PROPOSED
PROFESSIONAL
OFFICE PARK

PETITION NO: Z-53

Z-53 PALLADIAN, INC.

ZONING PLAN

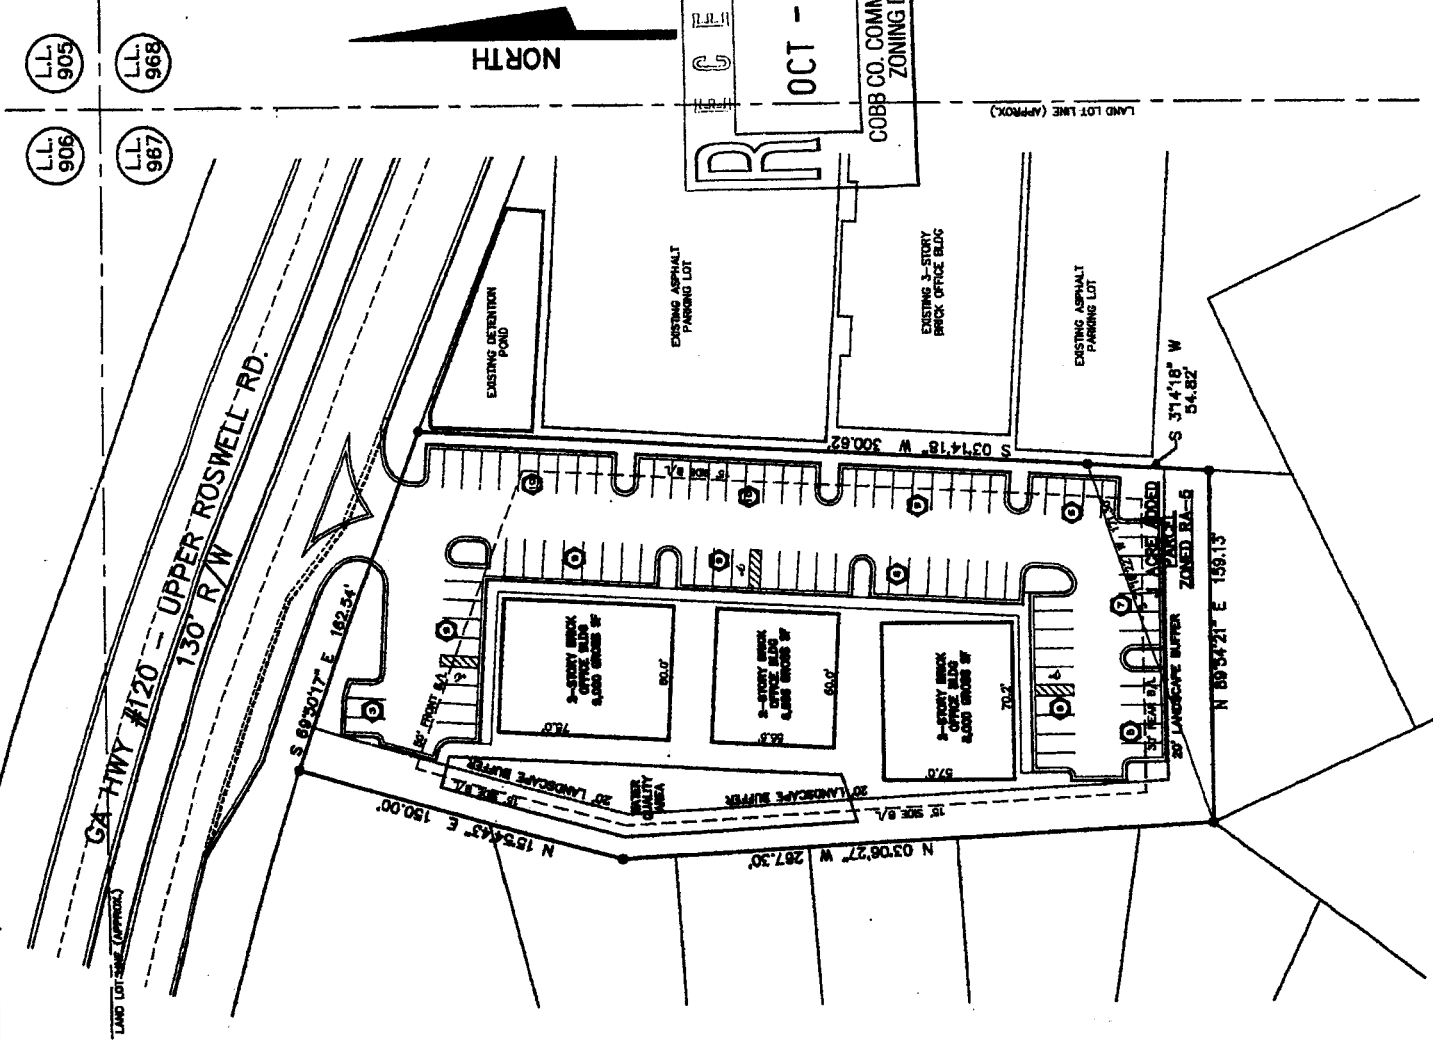
- Provide comprehensive hydrology/stormwater controls to include development of out parcels.
- Submit all proposed site improvements to Plan Review.
- Any **spring activity** uncovered must be addressed by a qualified geotechnical engineer (PE).
- Structural fill _____ must be placed under the direction of a qualified registered Georgia geotechnical engineer (PE).
- Existing facility.
- Project must comply with the Water Quality requirements of the CWA-NPDES-NPS Permit and County Water Quality Ordinance.
- Water Quality/Quantity contributions of the existing lake/pond on site must be continued as baseline conditions into proposed project.
- Calculate and provide % impervious of project site.
- Revisit design; reduce pavement area to reduce runoff and pollution.

- No Stormwater controls shown _____
- Copy of survey is not current – Additional comments may be forthcoming when current site conditions are exposed.
- No site improvements showing on exhibit.

1. The majority of this site drains to the west through the rear yards of lots 48 – 50 in the adjacent Glenside S/D. There is not a well defined conveyance through these lots sufficient to carry the increased runoff volume expected from this development. Therefore, the discharge from the proposed detention pond must be tied directly to the existing stormdrainage system within the Roswell Road R/W. The peak design discharge will be subject to the available system capacity.
2. The proposed detention pond must be well-screened from the adjacent residential lots. Any exposed pond walls must be decoratively faced.

Recommend a right-in/right-out driveway with a raised concrete island.

Recommend applicant seek inter-parcel access with parcel along the eastern property line.
